AMENDMENT NO. 1 TO SOLICITATION

DATE: August 30, 2018
TO: ALL VENDORS
FROM: Tracy Fountain
SUBJECT: USC-RFQ-3345-TF
DESCRIPTION: **Furnish, Deliver and Install Valcom – Support Security Alert System at USC Beaufort Campus**

FLOOR PLAN- LEVEL 1

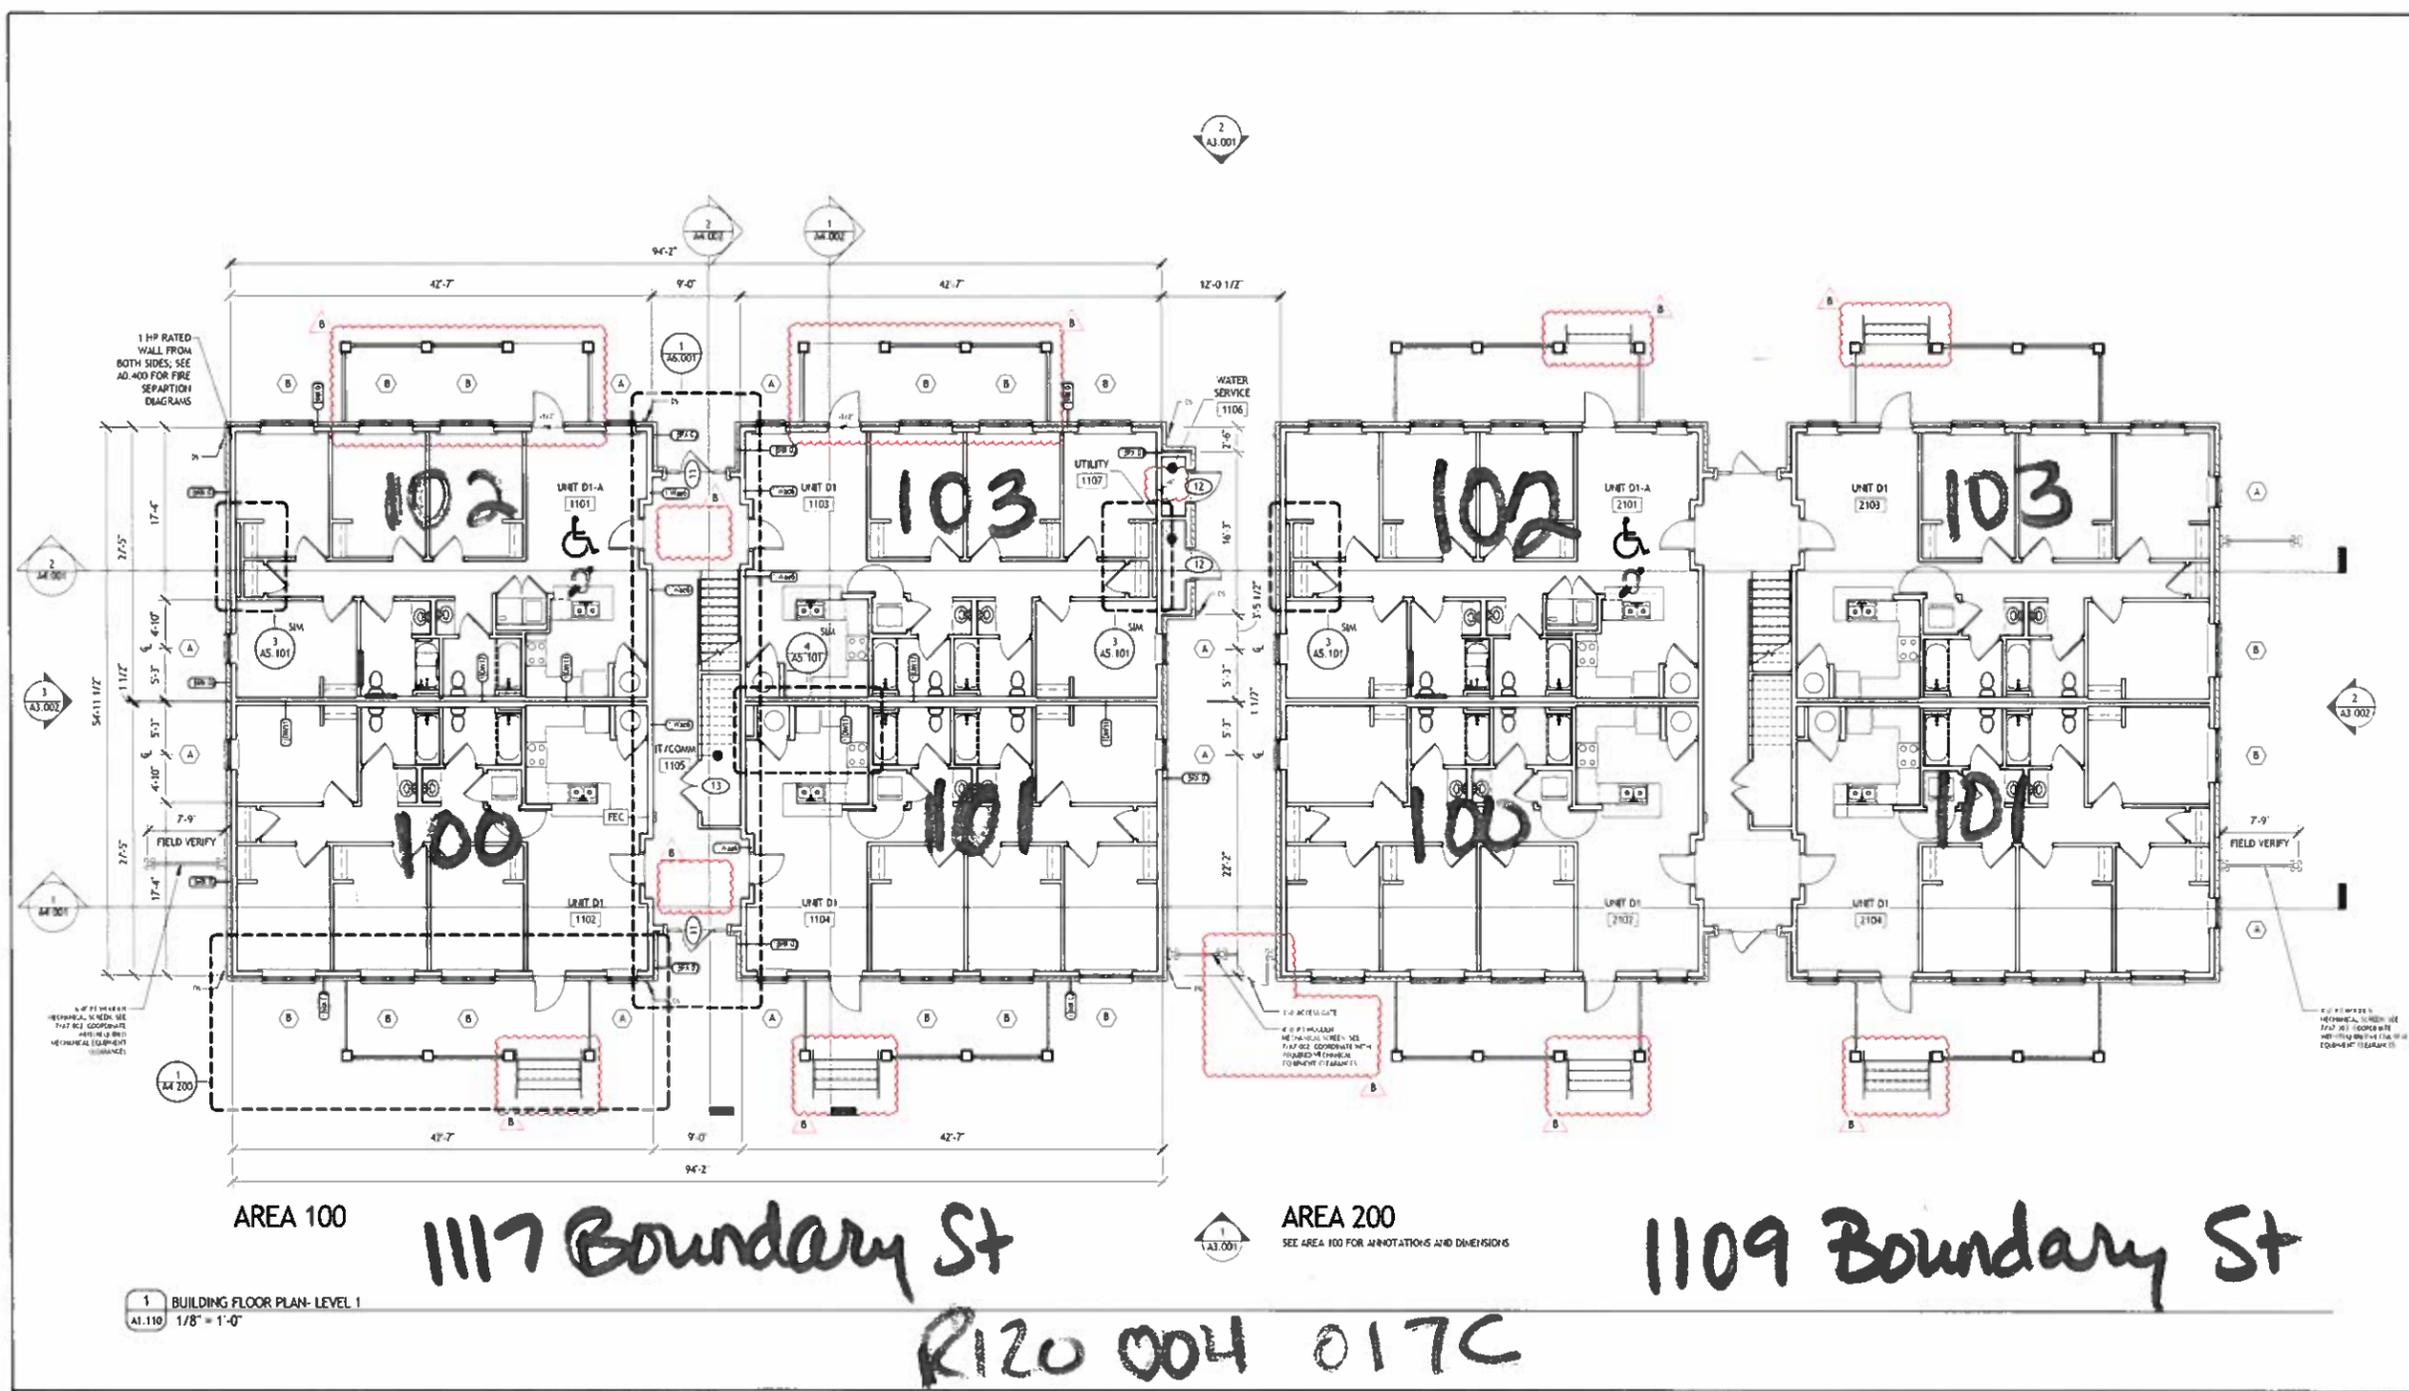
1. Could you provide a drawing for the layout of the requested system?

Answer: Attached is a floor plan encompassing both student Housing buildings for this installation. The vendor has moderate freedom to place the system in a manner that allows students to hear the alerts from their rooms. USCB IT provides power outlets and a data network connection in IT Closets. The quote for 6 total speakers assumes placement of 1 functioning speaker in the stairwell breezeway on each of the 1st, 2nd, and 3rd floors of each of the two Housing buildings.
